Objection to Planning Application PL/2026/03683

Cannings Hill Garage, Horton Road, Devizes, SN10 2JG

Proposed McDonald's restaurant/takeaway with drive-through facility, car parking, landscaping and associated works, including Customer Order Displays

Objector: Paul Howlett

Proximity of the proposed 24-hour drive-through and illuminated signage to Elder

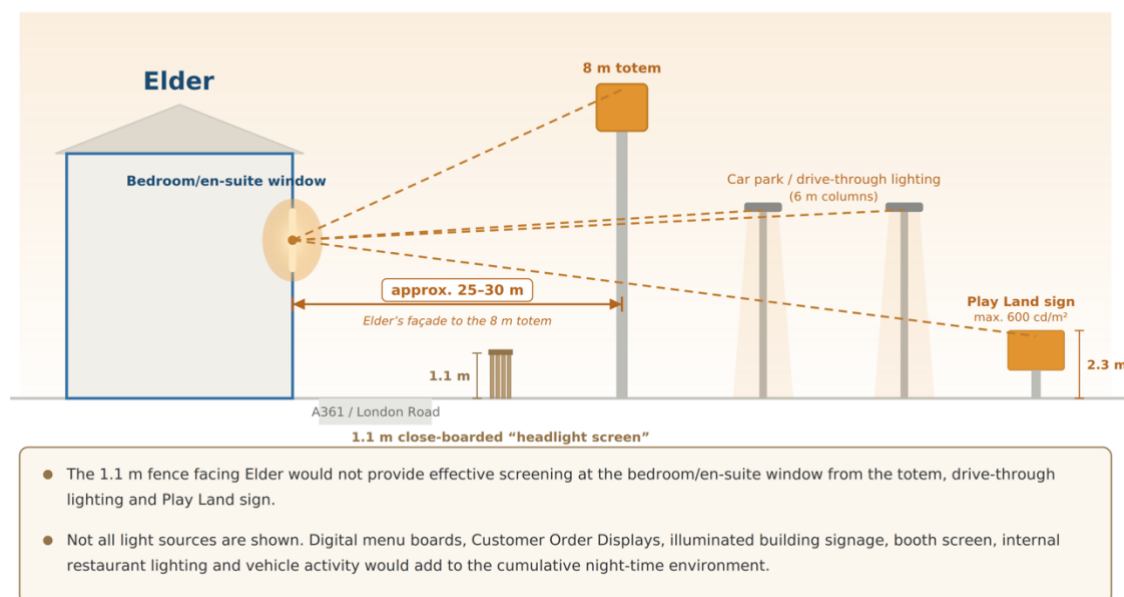
The following indicative section shows why the proposed 1.1 metre close-boarded “headlight screen” would not provide effective screening for the first-floor bedroom/en-suite at Elder from the 8 m totem, 6 m lighting columns, Play Land sign and wider illuminated drive-through environment.

The diagram is not to scale and is based on the applicant's submitted layout, signage and lighting information. Not all light sources are shown; digital menu boards, Customer Order Displays, illuminated building signage, the booth screen, internal restaurant lighting and vehicle activity would add to the cumulative night-time environment.

This proximity is also relevant to the wider amenity impacts considered in Sections 7, 10, 12 and 14. The applicant should provide verified sightline sections and lux calculations for first-floor residential receptors.
